DESIGN STATEMENT and RESPONSE to MSDC Pre-Application Email dated 6th January 2026:

3 Turners Mill Close
HAYWARDS HEATH
RH16 1NL

Ground Floor Extension and
Loft Conversion/Extension.

PROPOSED : Elevations Comparison

ReDesign 2 2026 : ELEVATIONS Proposed for Pre-Application dated 30JAN26:-

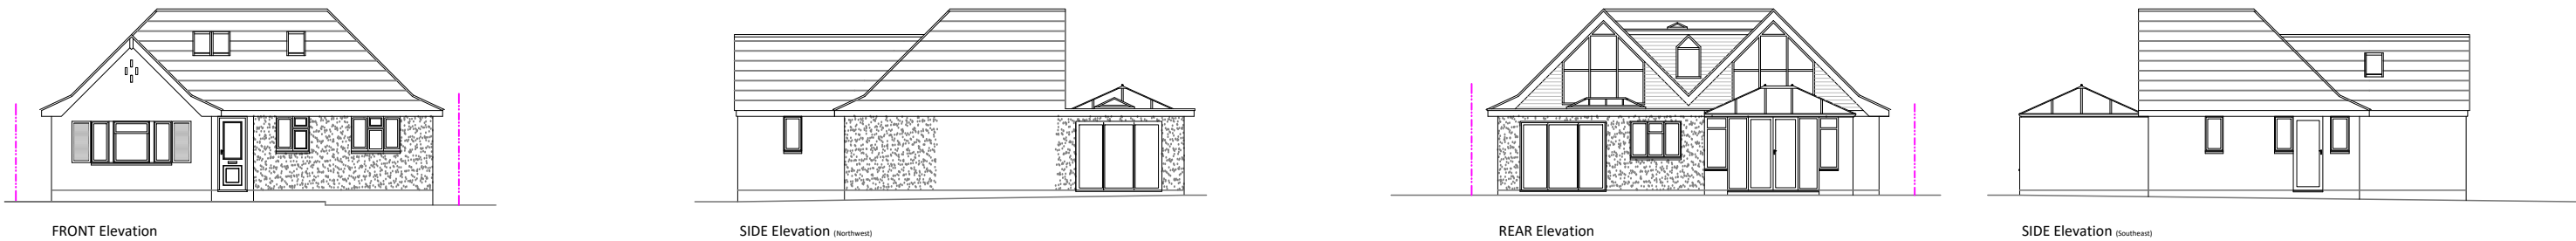
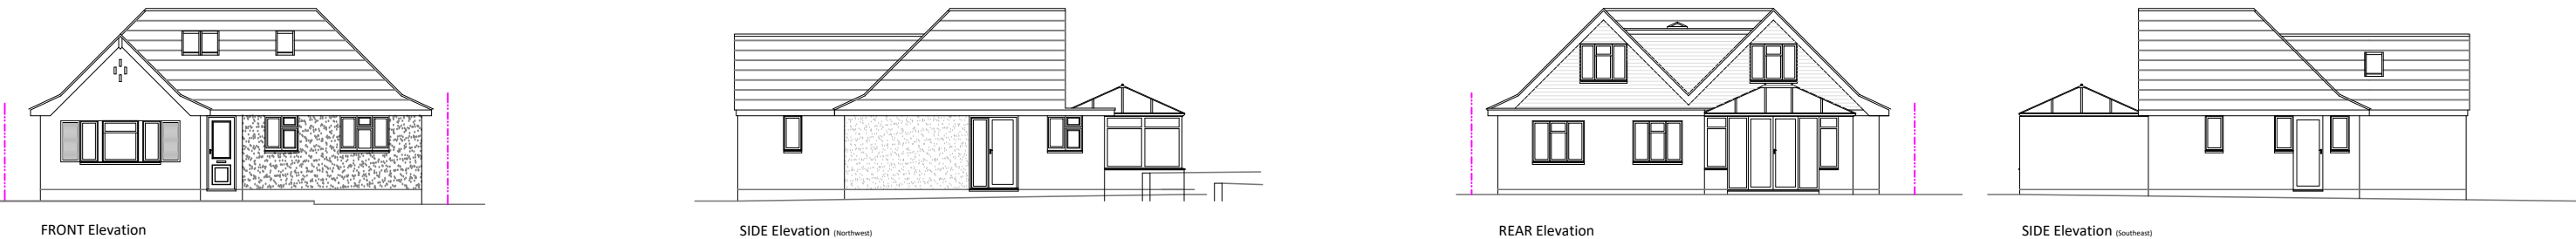
In response to :
"The proposed rear dormer is considered to be of a large flat roof design, which is out scale with the original dwelling".

"In addition, the proposed glazing pattern appears cluttered and, due to a large amount of glazing at first floor level, creates a greater sense of overlooking."

Impact on neighbouring amenities
Policy DP26 of the MSDP requires development not cause significant harm to the amenities of existing nearby residents and future occupants of new dwellings, including taking account of the impact on privacy, outlook, daylight and sunlight, and noise, air and light pollution.
As set out above, it is noted that the proposal includes significantly more glazing on the rear elevation at first floor level than the existing arrangement which creates a greater sense of overlooking and can lead to direct views into the neighbouring property's private amenity space.

The design of the gables as an 'extension' not as 'dormers' and reflects the examples noted closely follows the principles demonstrated in MSDP 'Roof Design', page 99 : Figure 6C using a proportionate 'hipped' roof design to successfully soften the elevational views, with the ridge height being maintained uniformly in line with point MSDP 6.3.10, and generally DG38's requirements noted in the introduction section.

Additionally the flat area roof equals less than 8% of the whole roof area and therefore is not proportionately large and nor out of scale to the roof as a whole.
The rear elevation design is:
- Balanced proportionally with the gable i.e. in 'thirds' in line with MSDG 6.3.5,
- Below the ridgeline as per 6.3.7,
- The face wall line is set into the rear elevation thus is integral to the roof as per example on MSDG page 98 - top right picture, to work harmoniously and compliment the overall roof form.

Accepted, and note the preceding design has been heavily amended to further meet MSDG 6.3.1 and 6.3.2 with the reduction of the number of windows, the total glazed area and height of the windows, plus a more 'contemporary' design to compliment the existing fenestration and facade. Also note that the original design was intended to particularly to meet MSDG 6.3.2 points 1 and 2 :

Accepted, and note the preceding design has been heavily amended to reduce the impact on privacy by reducing the number of windows and the individual window area. We note that any future development in the college field opposite will also be required to afford the residents on No. Turners Mill the same privacy and meet with Policy DP26.
